Service Bulletin

Solenoid box breaker modification

All GA8 serial numbers up to S/N GA8-06-098

Document: Service Bulletin SB-GA8-2008-50

Figure 2 - Showing the first two wires to be disconnected

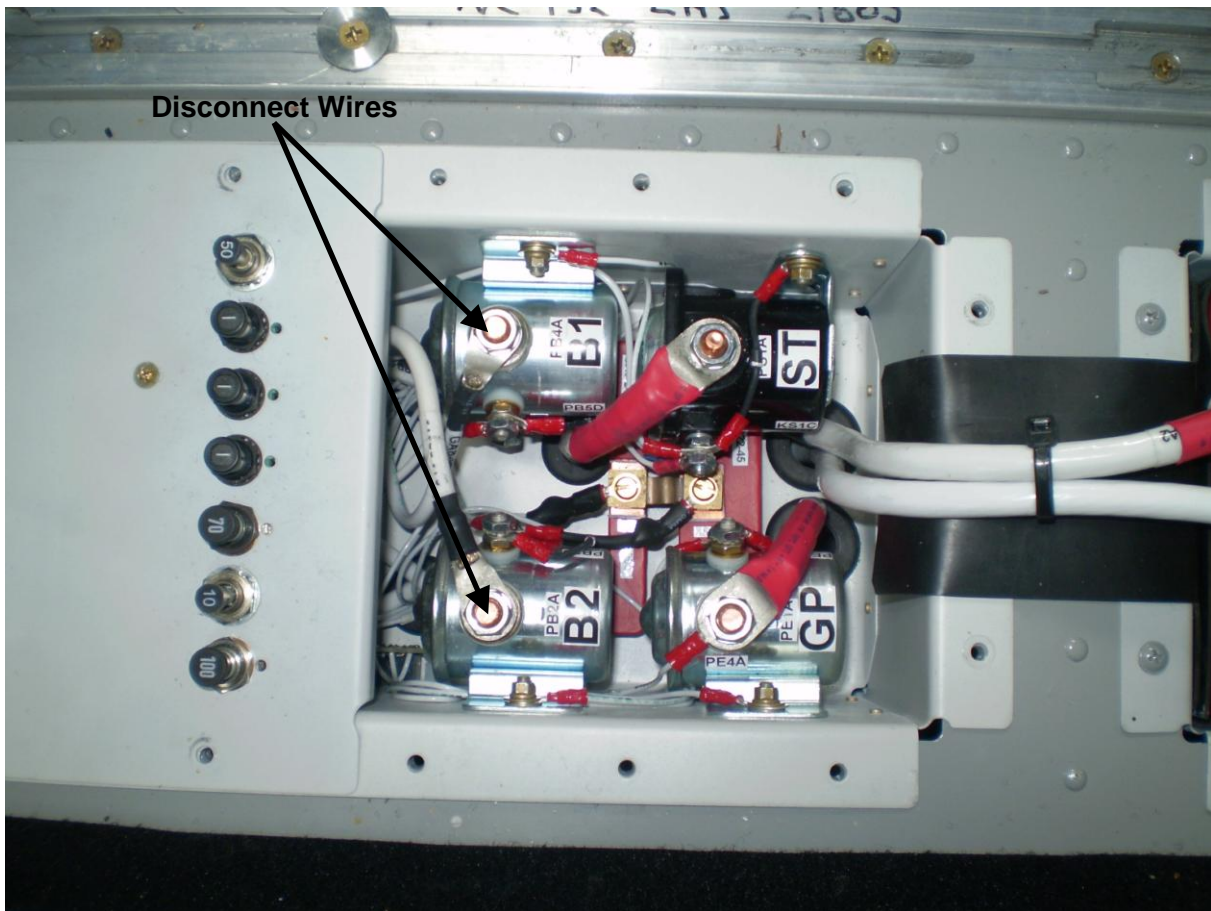
- Gain access to the Circuit Breaker Assembly and remove this from the main solenoid box assembly. This will require disconnecting of wires PB4A8, PB4B8, PB2A6, PB2B6 to ease the modification of the circuit breaker panel. Refer to Figure 2. Remove the existing 1A breakers from the assembly and discard. Retain the bus bar (GA8-311022-33) for reinstallation.

Figure 3 - Modification to Breaker Panel, viewed from above when fitted into aircraft

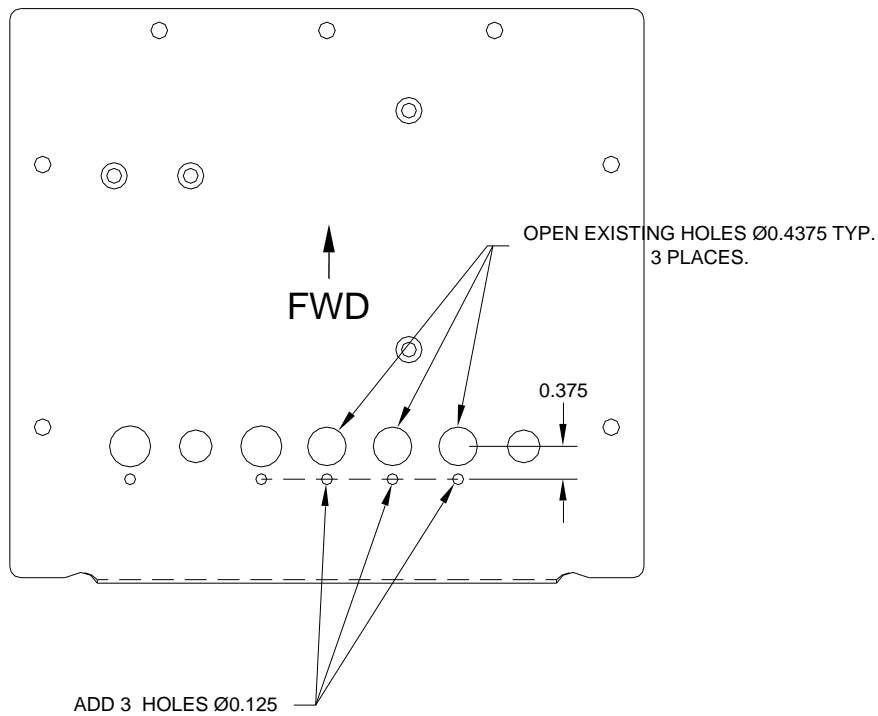
5. Modify the Breaker Panel as detailed in Figure 3. Each new breaker requires the existing mounting hole to be enlarged to 0.4375 inches diameter and the addition of a 0.125 inch diameter hole per location. Remove all swarf.

Figure 5 - Partial wiring schematic showing underfloor circuit breakers.

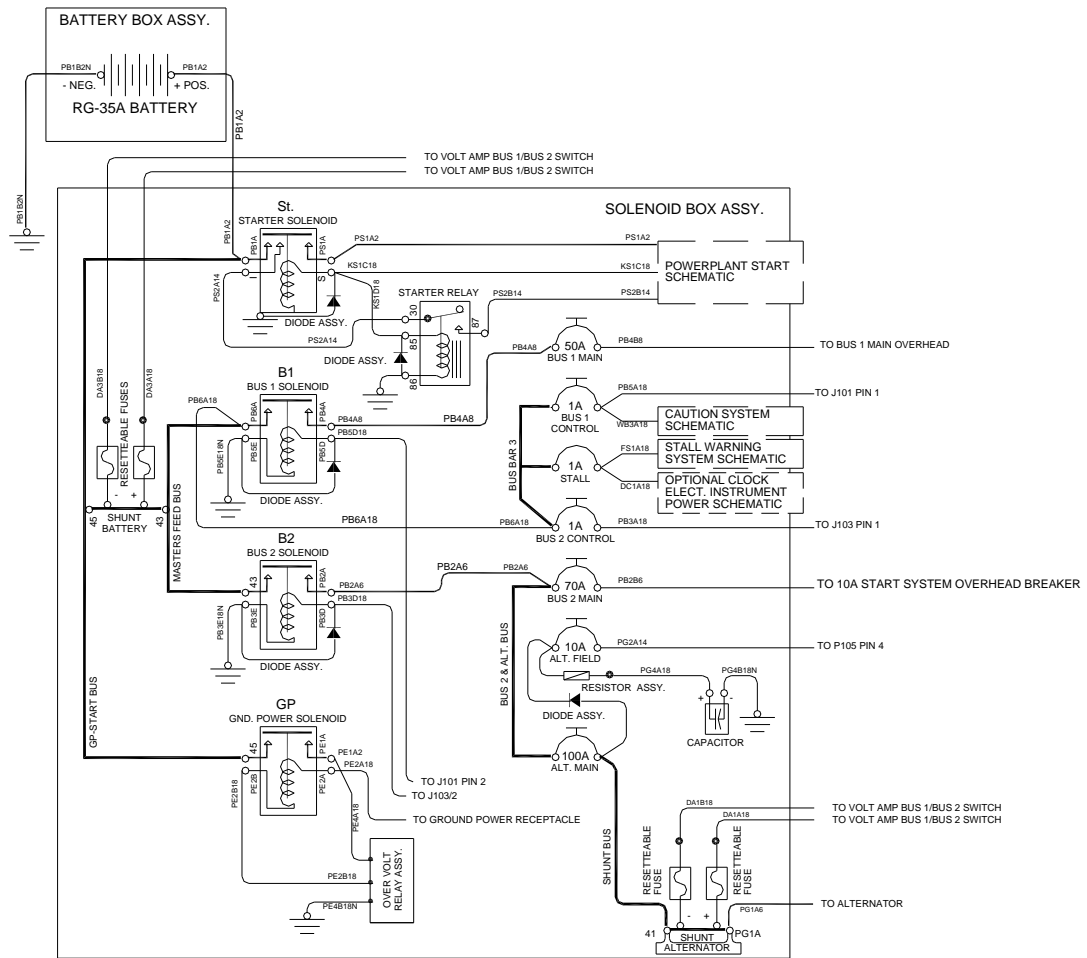
- Refit the Circuit Breaker Assembly to the solenoid box. Refer to Figure 5 for the wiring to circuit breakers. Refer also to Chapter 24, Figure 24-1 of the Service Manual
